Subject: Draft 1 of Version 7 ENERGY STAR® Computer Specification

This letter comprises the comments of the Pacific Gas and Electric Company (PG&E), Southern California Gas Company (SoCalGas®), San Diego Gas and Electric (SDG&E), and Southern California Edison (SCE) in response to the U.S. Environmental Protection Agency's (EPA) Version 7, Draft 1 ENERGY STAR® Computer Specification.

Figure 1: Analysis of 87 desktop configurations show most systems reporting 2 to 16 times the amount of memory available in retail configurations

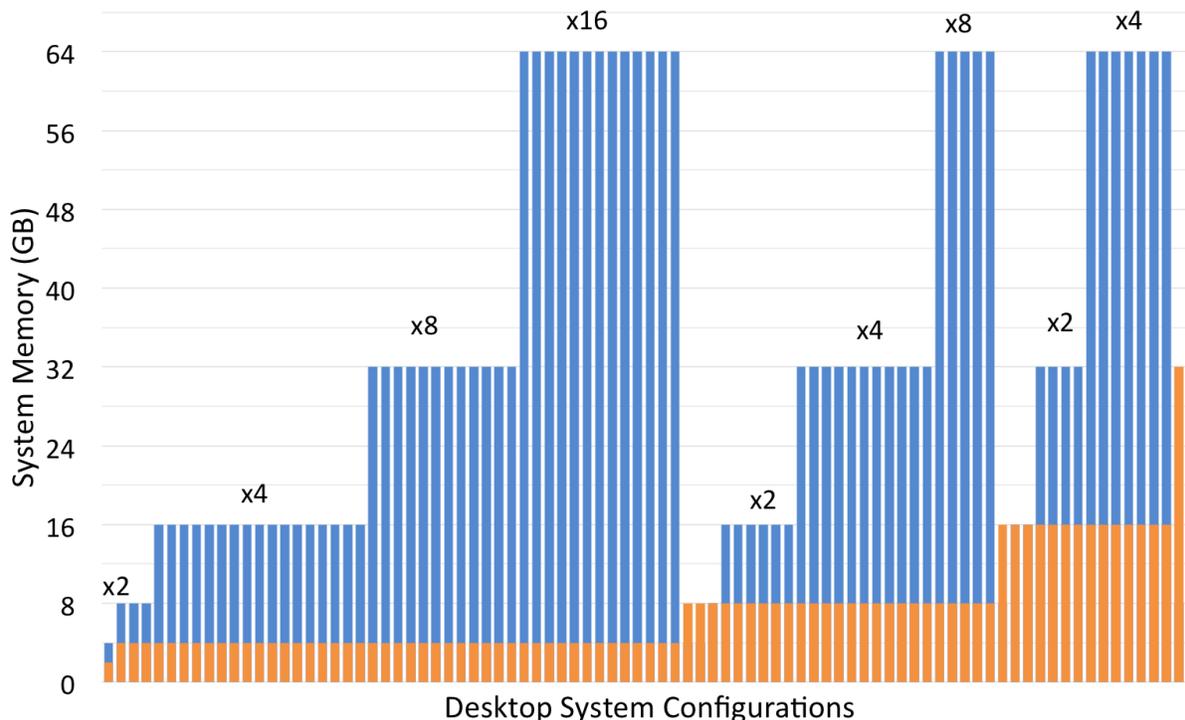
1) **We recommend that EPA address oversights in its memory adder and model certification approach to ensure that certified model configurations reflect those that are available for sale.**

EPA's Draft 1 specification maintains a capacity-based approach for memory TEC allowances. Desktop computers are afforded a 0.8 kWh/yr/GB allowance and notebooks a 0.4 kWh/yr/GB allowance. Though relatively innocuous in appearance, the structure of this memory adder combined with current certification requirements has resulted in unintended adverse consequences. Analysis of the Version 6.1 CPL shows that the memory installed and reported in CPL configurations is almost always significantly higher than the capacities available in retail configurations. As a result, manufacturers are able to claim large TEC allowances for memory configurations that consumers cannot directly purchase.¹

Through collaboration with Natural Resources Defense Council (NRDC) and analysis of its draft Desktop Expandability Dataset, we have documented the extent to which this problem affects certified desktop models. NRDC's Desktop Expandability Dataset provides additional hardware attributes for product families certified since 2015 from manufacturers Dell, HP, Lenovo, Apple, Asus, Acer, and MSI. As shown in Figure 1, over 90% of the product families we surveyed were certified with significantly more installed memory — anywhere from 2 to 16 times more — compared to matching configurations available at retail.² In most cases it is impossible to find products that ship with the amount of memory reported in the CPL. This can result in over 40 kWh/yr of additional TEC allowances in desktops, depending on the size of the memory gap, with systems receiving on average about 10% additional TEC allowance.

We note that this additional allowance is not a determining factor for meeting the TEC requirements in any of the systems we have examined to date. Rather, it makes the specification far more lenient in practice than it should be, and this effect could become a significant factor in qualification in the future as other aspects of the specification are tightened if it is not addressed. We have only examined the issue of hardware over-reporting as it relates to installed memory, but the issue could conceivably manifest itself in other areas of the specification where hardware-based adders are granted.

Current language on certification of a “Product Family” (section 4.2.1) instructs manufacturers to certify “Representative Models” and that “product configurations that represent the worst-case power consumption for each product category within the family are considered Representative Models.” We recommend that EPA further clarify that a Representative Model must be available for purchase through retail channels in applicable locales/markets in the *exact* configuration certified.

Figure 2: Installed memory capacity in retail and CPL configurations

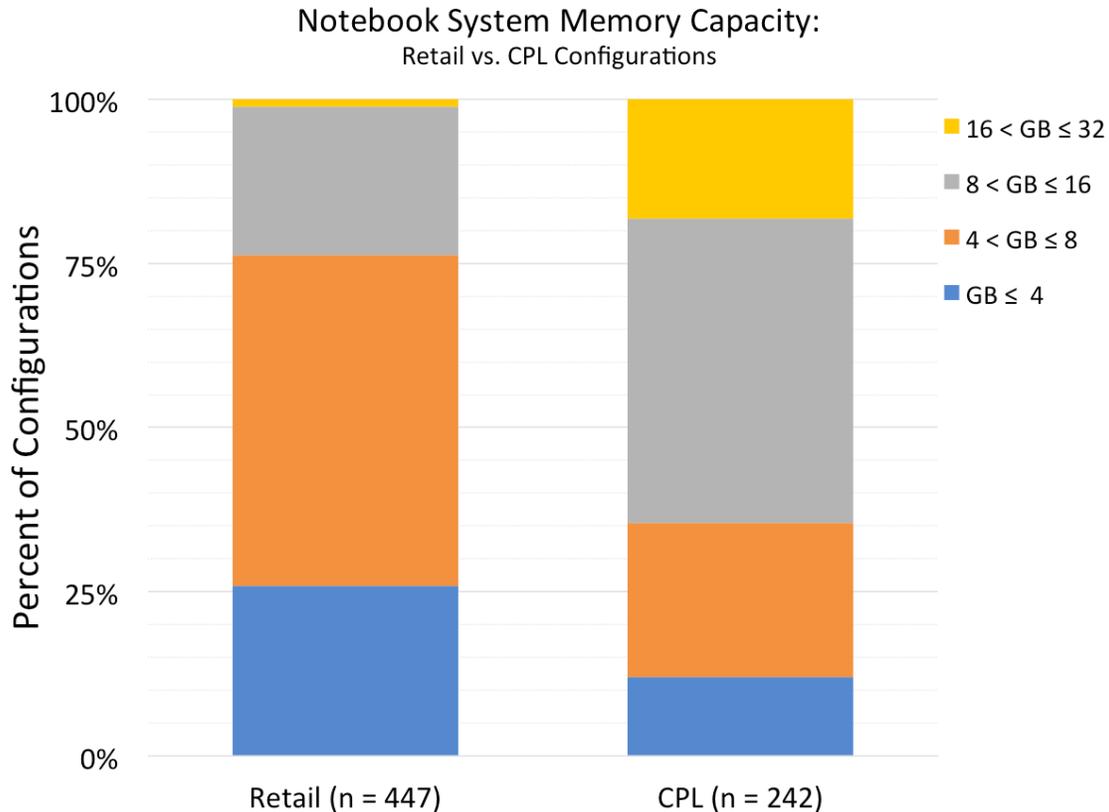
Additional research by the CA IOUs suggests that the memory over-reporting issue may be present in certified notebooks as well. Since we do not have a matched retail dataset for notebooks, such as the one developed by NRDC for desktops, we have used broad market analysis to examine the issue. Figure 2 provides a distribution of memory configurations for Version 6.1 certified notebooks compared to memory configurations currently available from Dell and HP (based on models currently listed on their websites). Systems in the ENERGY STAR CPL skew significantly toward larger memory configurations (most systems report more than 8 GB of installed memory) compared to those available through manufacturers' online storefronts.

The CA IOUs firmly believe that TEC requirements for ENERGY STAR product families should be based on hardware configurations that are actually available for purchase by consumers. This reflects the spirit of the ENERGY STAR program itself by providing consumers with transparent and accurate information to motivate more energy-efficient purchasing decisions. We recommend that EPA adjust its certification requirements to ensure that the language in Version 7 is unequivocal on this issue.

Figure 3: Relationship between estimated TEC and sleep power for a typical desktop with different allowed duty cycles

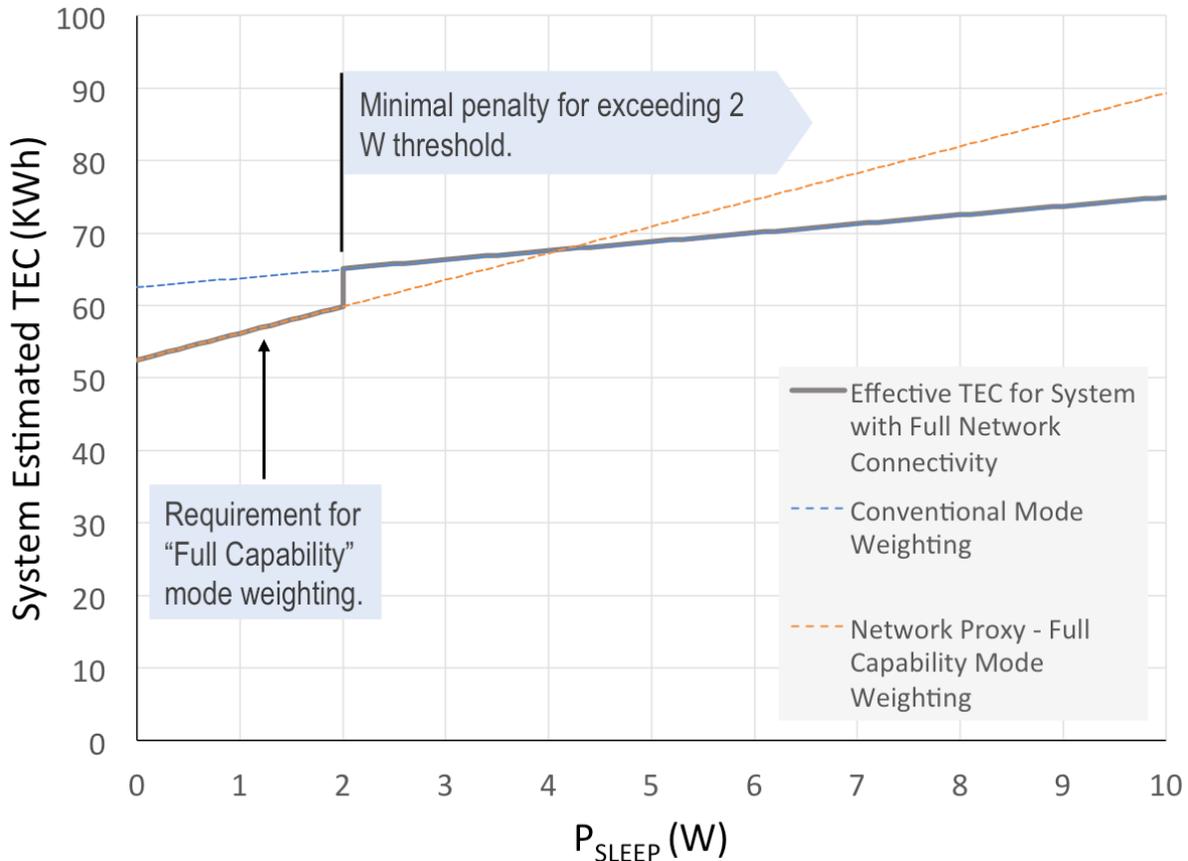
Section 3.5.1(iii) describes criteria that must be met in order for manufacturers to utilize the “Network Proxy – Full Capability” mode weighting, described in Table 3 of the draft. In addition to requiring that products comply with the ECMA 393 proxy standard, the language requires that sleep power be maintained at or below 2 W while providing full network connectivity. However, on the following page in section 3.5.1(iv), EPA describes a set of requirements whereby products with an “alternative low power mode” (i.e. one that does not conform to the definition of “System Sleep Mode” defined in section 1(D)(4)) are allowed to utilize the alternative low power mode in place of sleep mode as long as its power is no greater than 10 W. The language is unclear on exactly how an alternative low power mode is defined, so we assume that a network-connected sleep mode could be treated as such.

Since the CA IOUs and other stakeholders are currently not privy to the data shared with EPA by industry on network-connected low power modes, it is difficult to judge whether network-connected modes like Modern Standby and Power Nap will be able to achieve EPA’s stated 2 W target for sleep modes with full network connectivity. However, the alternative low power mode provisions described above could provide an effective “safety valve” for Modern Standby/Power Nap systems to still comply with ENERGY STAR requirements even if they cannot achieve the 2 W target. Choosing to treat Modern Standby or Power Nap as an alternative low power mode would mean forgoing the Full Network Connectivity mode weighting, but would not significantly penalize systems. As Figure 3 illustrates, there is significant incentive to control sleep power to below 2 W by taking advantage of the Network Proxy – Full Capability mode weighting. If that cannot be achieved, there would be a small TEC jump of about 5 kWh/yr for systems with sleep power immediately above 2 W due to the Conventional mode weighting. Assuming a given system could afford the initial 5 kWh/yr difference in TEC, though, there is relatively little incentive to maintain sleep power lower than 2 W.

Our understanding is that the alternative low power mode approach was originally intended to accommodate computers systems that do not utilize a traditional sleep mode, such as ACPI S3. This might include Chrome OS products that use long idle mode as their sleep mode, for example. The alternative low power mode approach is not appropriate for new network-connected sleep states like Modern Standby and Power Nap. It will also not help EPA achieve its stated goal of “a constant network connection at power levels below 2 watts” as it does not provide manufacturers with a clear and unequivocal compliance path for systems implementing these new modes.

We recommend that EPA limit the applicability of the alternative low power mode approach in its Draft 2 language, prohibiting products with Modern Standby and Power Nap from utilizing this provision and clarifying that those products must certify using the Full Network Connectivity provisions described in sections 1(E)(3) and 3.5.1(iii).

Figure 4: Screen shot from a manufacturer support article instructing users on toggling of EEE functionality³

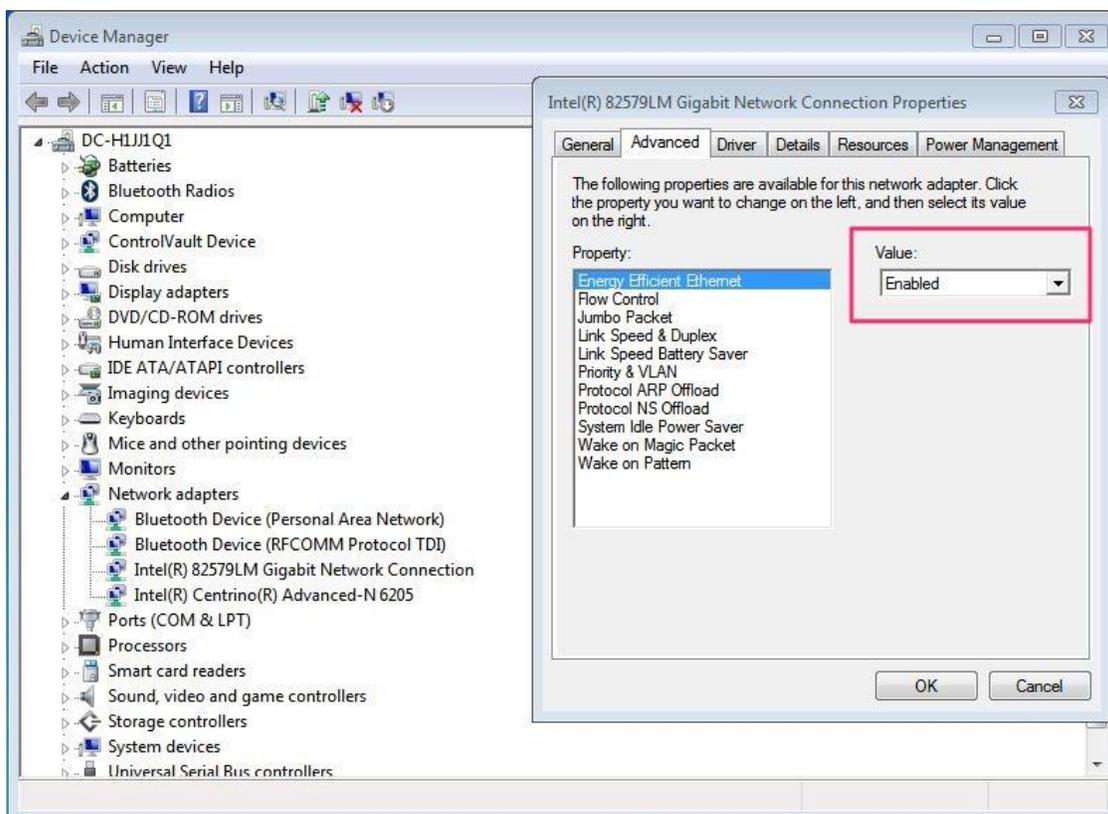
- 3) **We recommend that EPA tighten language for the Energy Efficient Ethernet (EEE) incentive by requiring that EEE technology is not only supported, but enabled as shipped.**

The current draft continues to provide an incentive in the form of a 0.7 kWh/yr allowance for computer models that incorporate an “IEEE 802.3az-compliant (Energy Efficient Ethernet) Gigabit Ethernet port.” The CA IOUs continue to support inclusion of this incentive as a means to foster adoption of highly efficient network protocols and technologies. However, we recommend that language be tightened to ensure that the Ethernet hardware is not only *compliant* with EEE, but that EEE features are *enabled by default* in the network adapter’s driver settings. As the screenshot below indicates, some drivers for Ethernet adapters can contain toggles for EEE functionality (Figure 4), and anecdotal experience has shown that certain models may ship with the feature disabled.
